Your Ref
WA/65/18/HH
Our Ref
PLAN-024435
Date
27/09/2018

Proposal: Retention of double garage & with new layout to screening to the North West highway boundary.
Site: Richmond House, Arundel Road, Walberton, BN18 0QP.
WA/65/18/HH

Southern Water MapGuide Browser

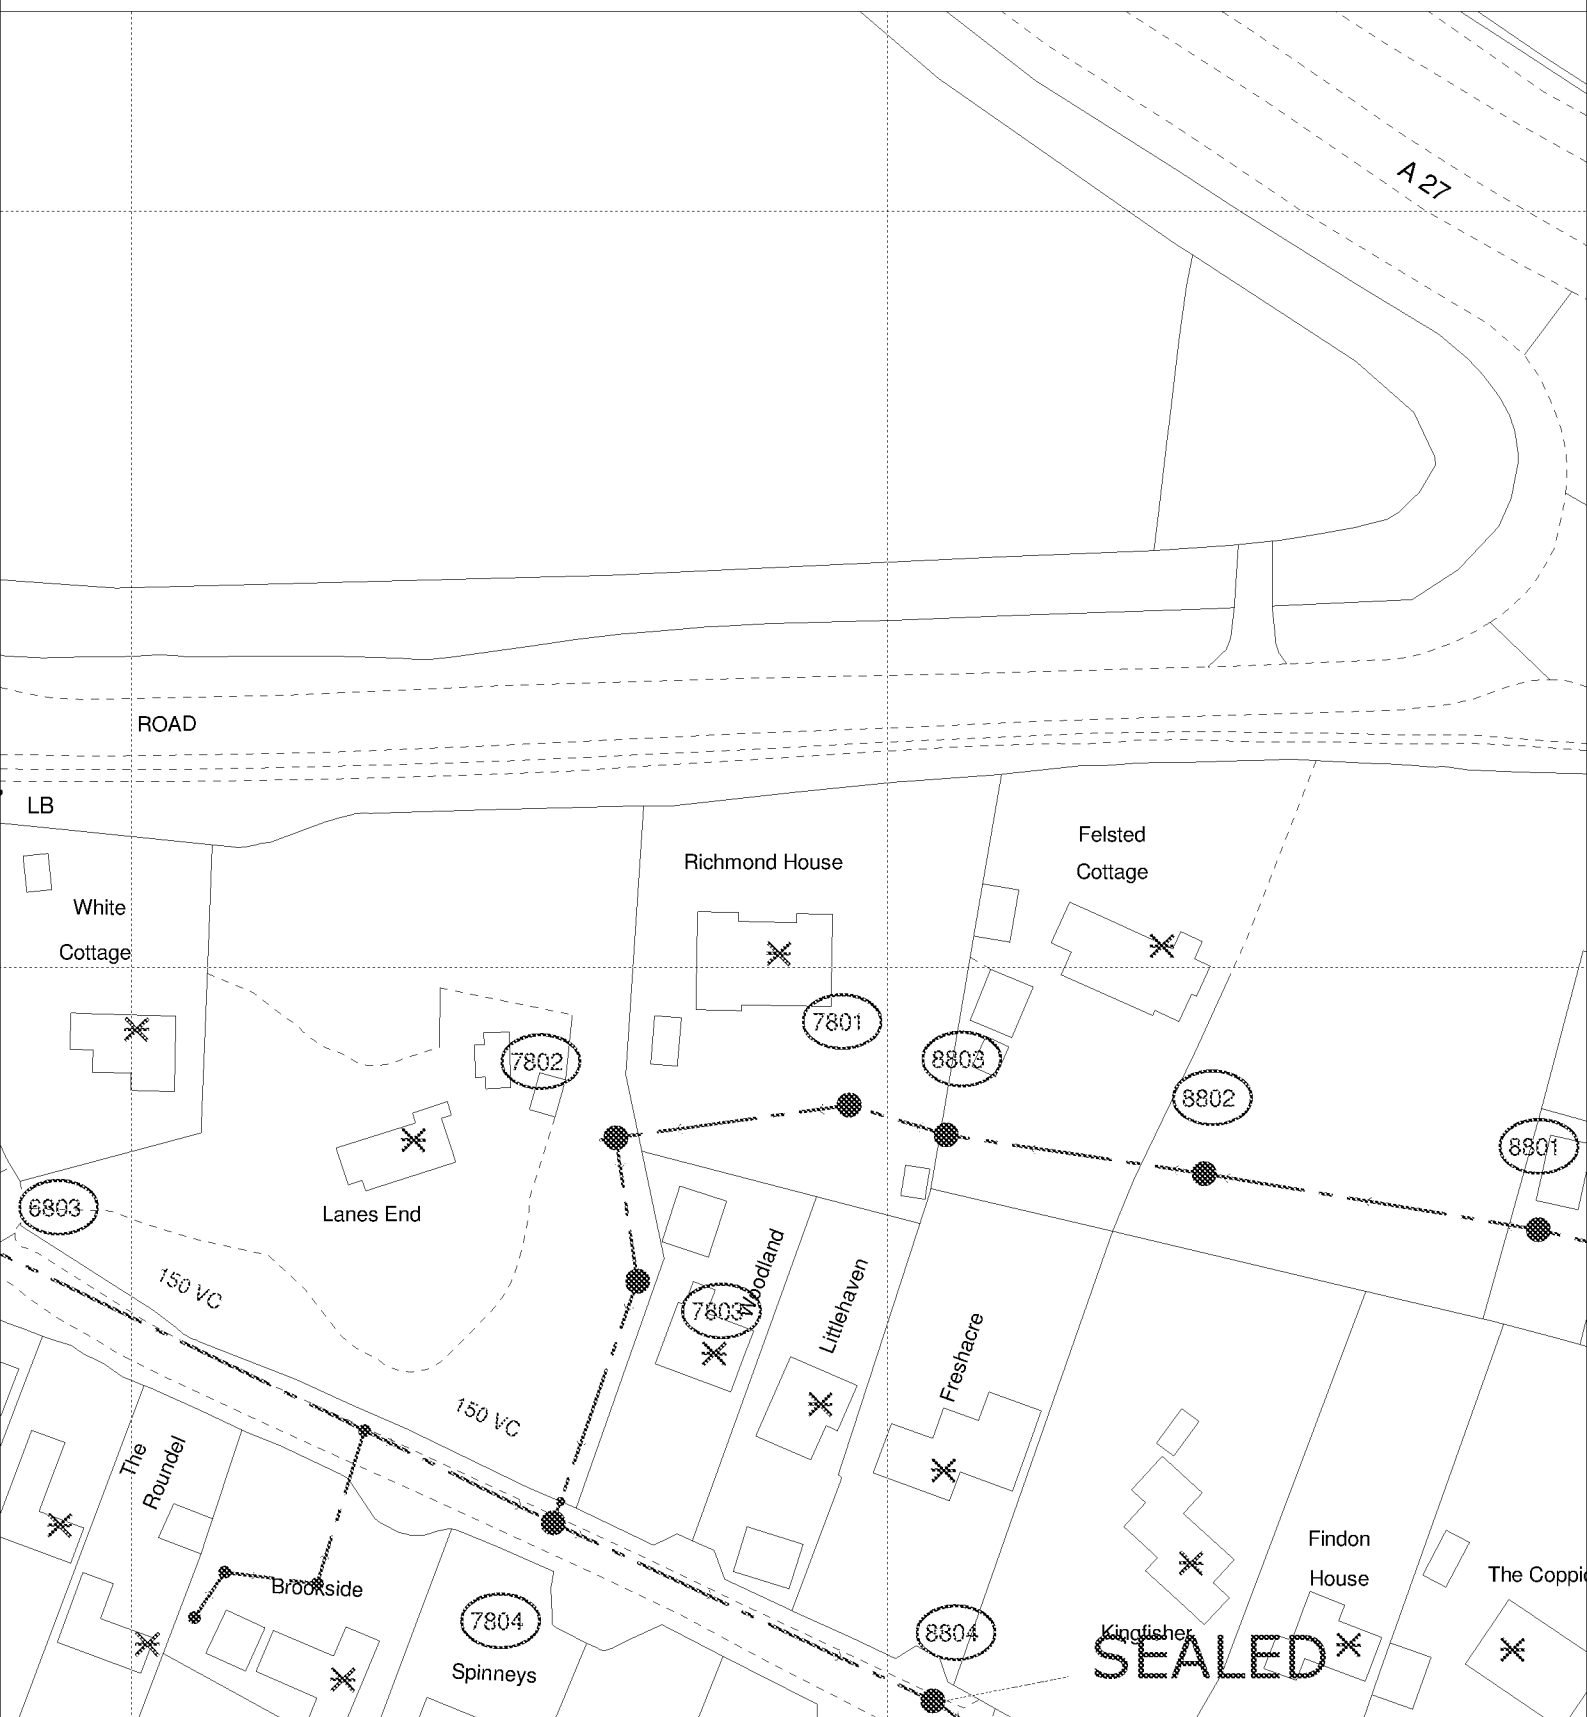
Please find attached a plan of the sewer records showing the approximate position of foul sewer within the site. The exact position of the foul sewers must be determined on site by the applicant before the layout of the proposed development is finalised.

- No development or new tree planting should be located within 3 metres either side of the external edge of the foul sewer.
- No new soakaways should be located within 5m of a public sewer.
- All existing infrastructure should be protected during the course of construction works.
